**MILWAUKEE TRANSPORT SERVICES, INC.**

**ADDENDUM NO:** 1  
**BID NO:** RFP MM-06-18 Entrance Gates and Controls  
**QUESTION DEAD LINE** October 3, 2018 – End of business day  
**OPENING DATE:** October 17, 2018 - 2:00 PM (CST)

Entrance Gates & Controls

## Fleet Property

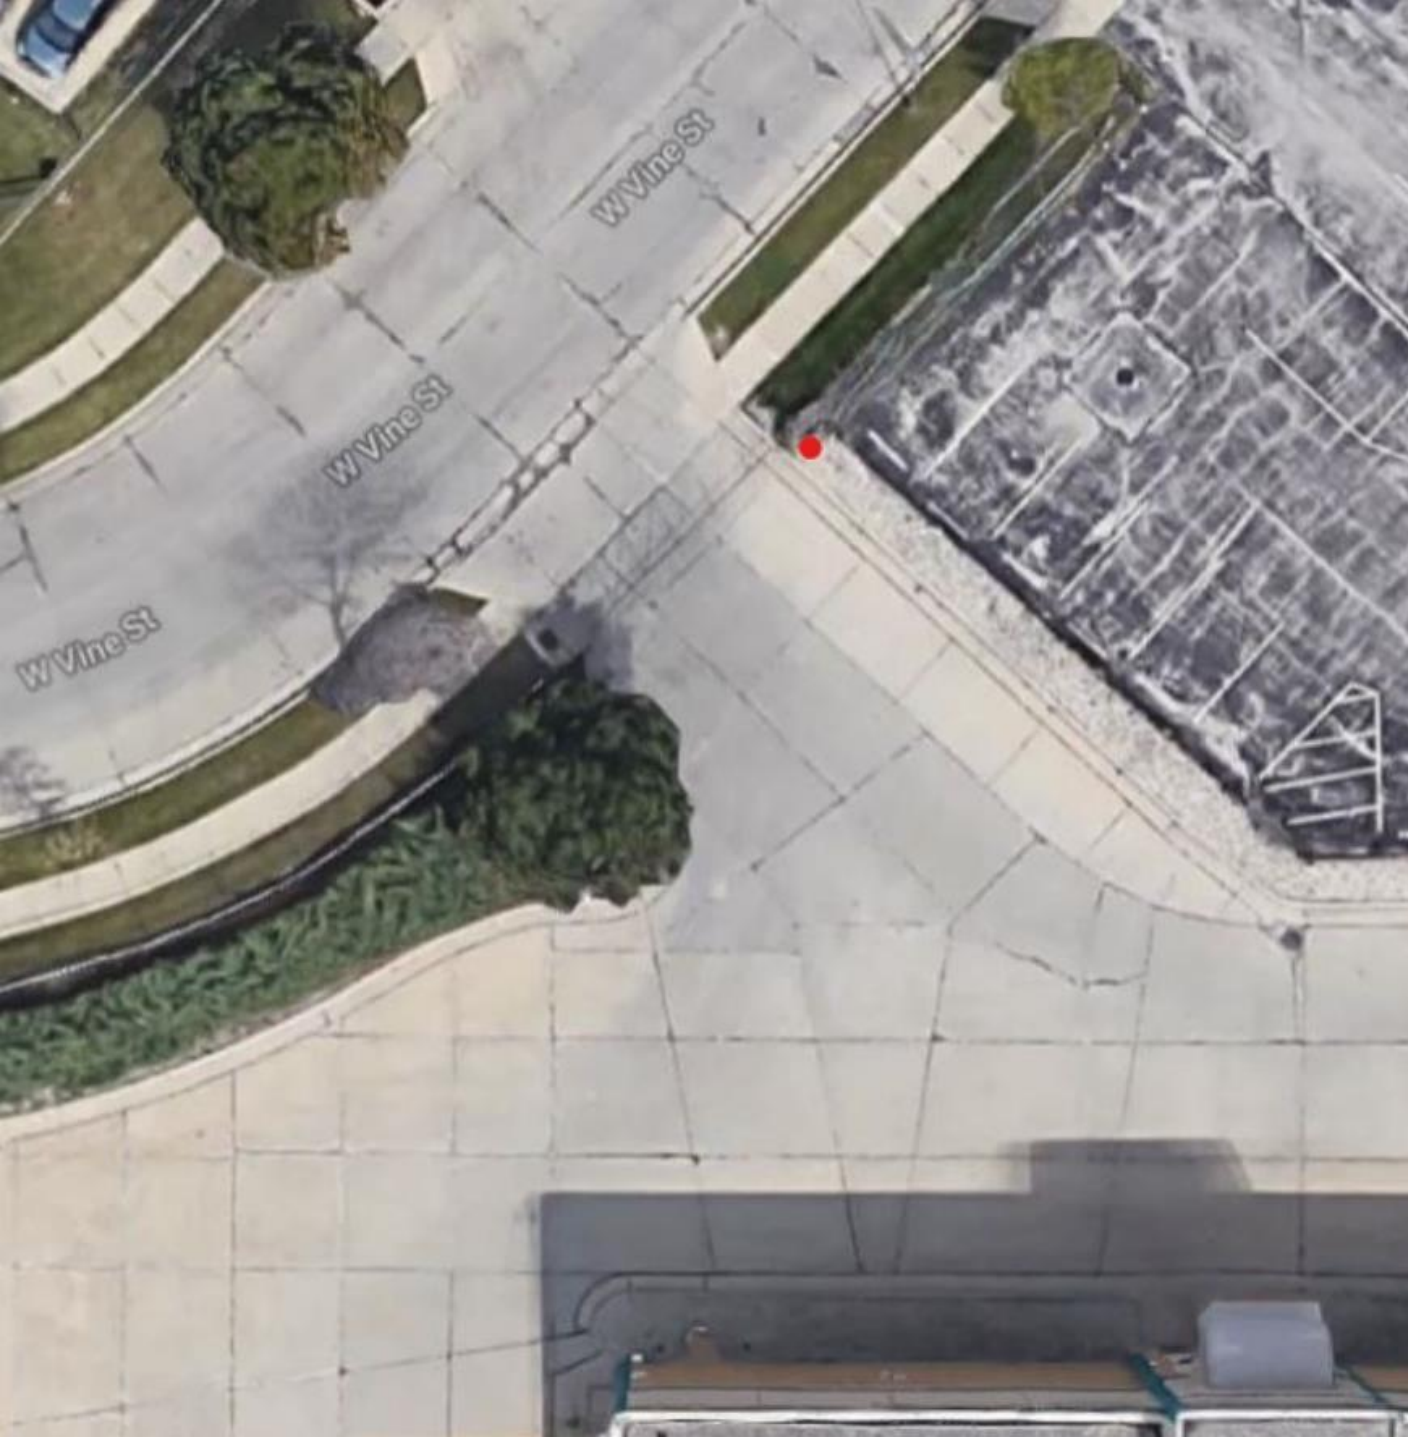
1. Will you make available Electrical construction Drawings, or will we have to investigate, Design & Build accordingly?

All Locations referenced for NEW sliding gates and barrier gates require Electrical restoration.

Power to gate was recently updated in a separate project. Red dot indicates current viable location.
